STAFF RECOMMENDATION

1400 Linden Avenue

May 21, 2014

Application: New construction-outbuilding; Setback determination

Figure 2. 1957 Sanborn map shows outbuildings located directly on the alley.

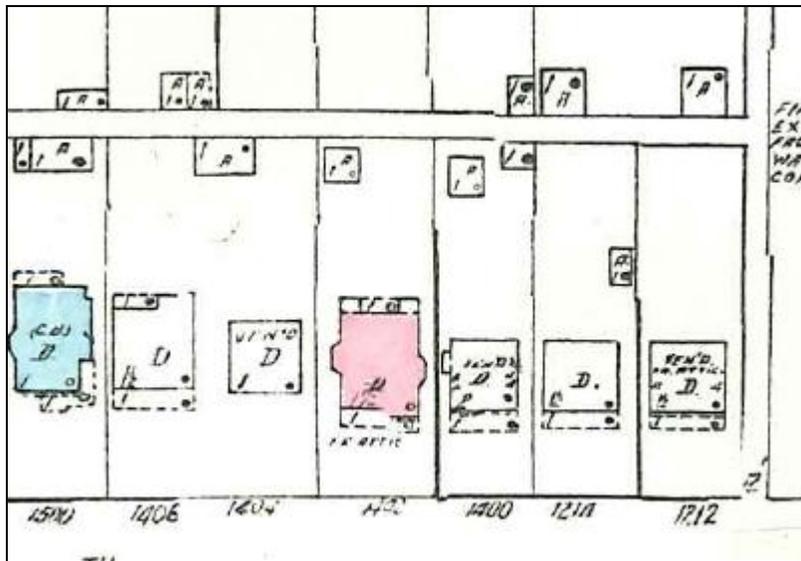
Location, Orientation and Setbacks: The proposed outbuilding will be located at the rear of the property with access from the alley, as is historically typical for outbuildings. Pedestrian access will be from the south side, which faces the house. Its location and orientation are consistent with the context. Because it is proposed to have a footprint greater than seven hundred square feet (700 sq. ft.), base zoning requires that the outbuilding be placed a minimum of twenty feet (20') from the alley and five feet (5') from the side property lines. The applicant requests a setback determination for the building to be ten feet (10') from the rear property line. Historically, outbuildings were located close to or right on the alley. There are also existing outbuildings in the district

closer than ten feet (10') to the alley; the Commission approved a five foot (5') rear setback for an outbuilding at 1500 Linden Avenue in 2010. For these reasons, Staff finds the setback determination to be appropriate; the project meets section II.B.I.2.

A2.0

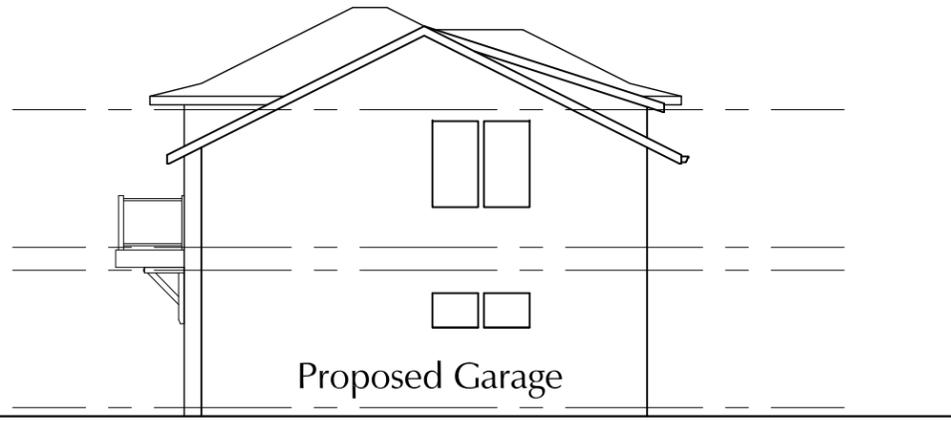
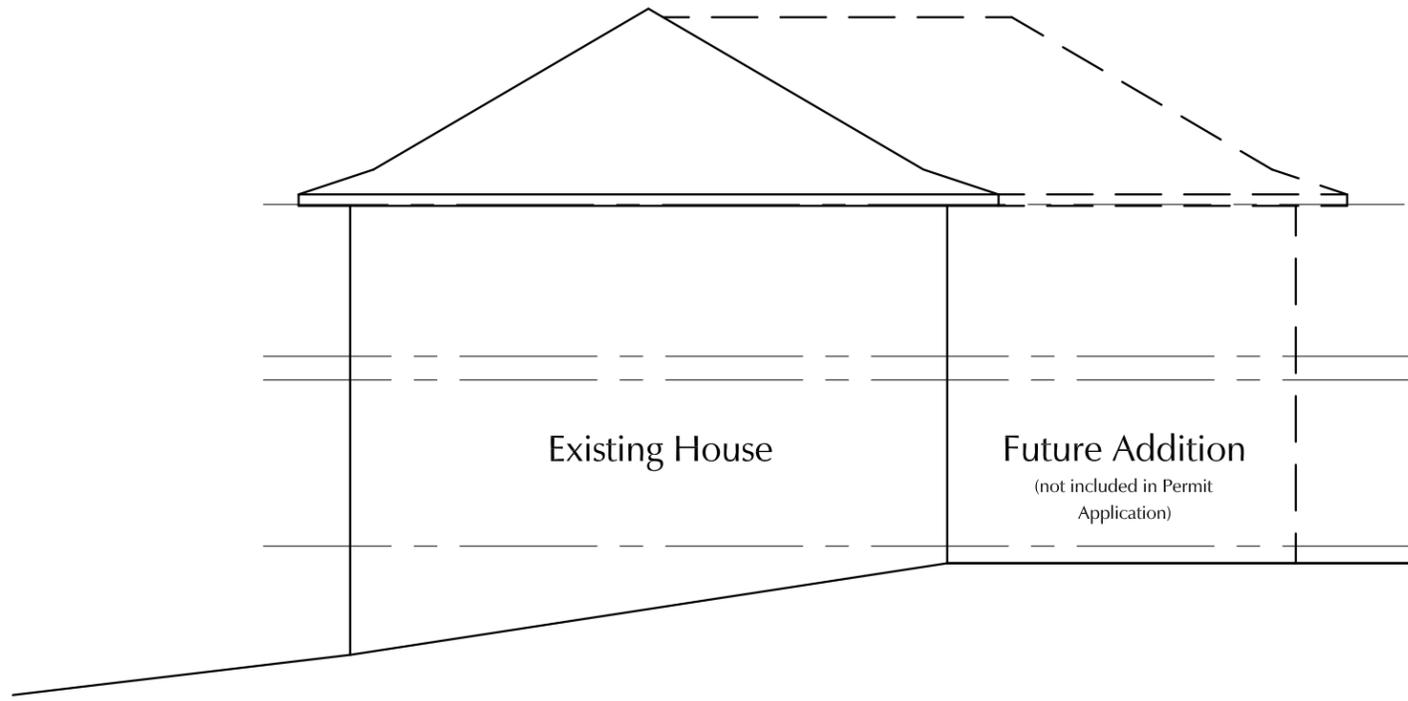
Materials: The outbuilding will be clad in smooth face cement fiberboard with a five inch (5") reveal. A portion of the second story will have cedar shakes. Trim, brackets and corbels will be wood. The foundation will be a concrete slab. The roof will be architectural fiberglass shingles. Staff requests final approval of the windows, doors, garage doors and color of roofing material prior to purchase and installation. With the staff's final approval of these materials, Staff finds that the project meets section II.B.I.1.

Roof Shape: The proposed outbuilding has an asymmetrical gabled and hipped roof form with 6/12 pitch. The hipped portion flares to 3/12 pitch at the eaves, matching the profile of the house. Wall dormers, not typical for a principle building, are appropriate in this location as they will not be seen from the street. The project meets section II.B.I.1.

Staff recommends approval of the proposed outbuilding with the condition that Staff provides final review of windows, doors, garage doors and color of roofing material.
